**From:** Gerry Houlder, Seagate Technology <gerry.houlder@seagate.com>  
**Subj:** SAS: Add low power transceiver options  
**Date:** Apr. 25, 2008

## Overview

## **SAS-2++ Changes (based on SAS-2 rev.14):**

Figure new1 – SAS COMWAKE recovery sequence  
 [editors note: Original Visio file for this figure available from Mark Evans.]

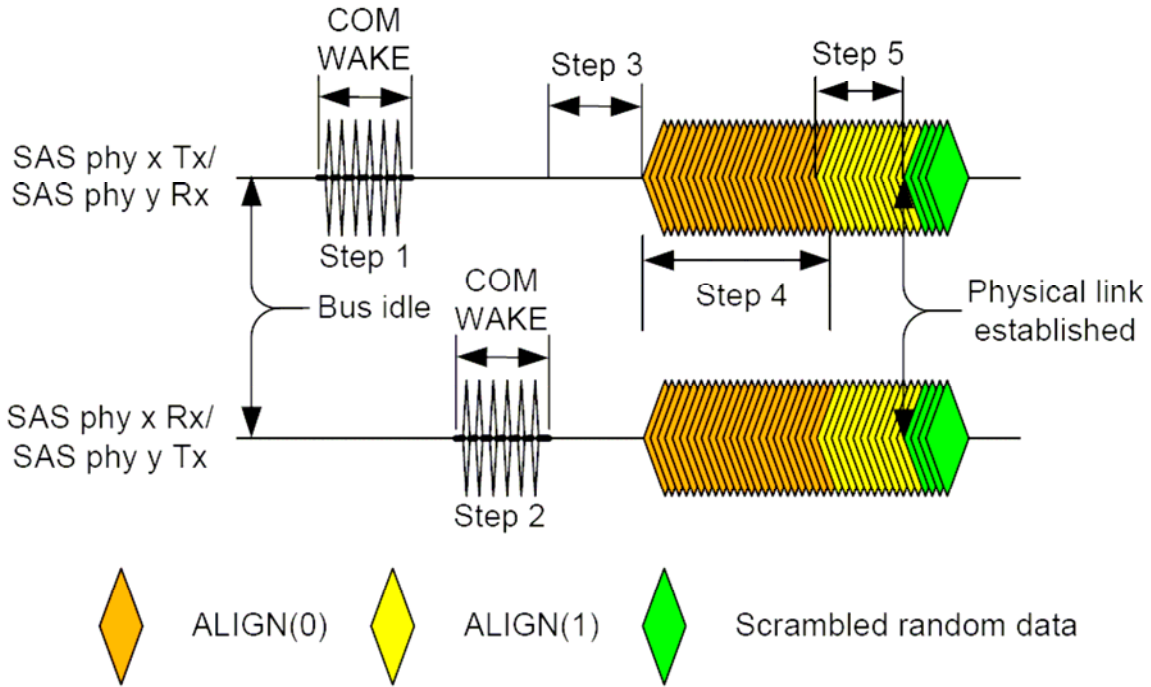
The sequence to recover from either partial or slumber power management state is shown in figure new1.

- 1) port x decides to wake up the link and initiates power management action to transition phy x to active state;
- 2) phy x transmits COMWAKE;
- 3) phy y detects COMWAKE, initiates power management action to transition phy y to active state, and transmits COMWAKE back to phy x;
- 4) both phys transmit ALIGN(0) primitives at previously negotiated settings;
- 5) when both receivers synchronize on ALIGN(0)s, the transmitters change to sending ALIGN(1)s; and
- 6) when both receivers synchronize on ALIGN(1)s, the transmitters change to idle dwords.

The link is now re-established with the same transfer rate and SNW3 settings (e.g., SSC mode and multiplexing mode) that were negotiated before the link was placed in power management mode.
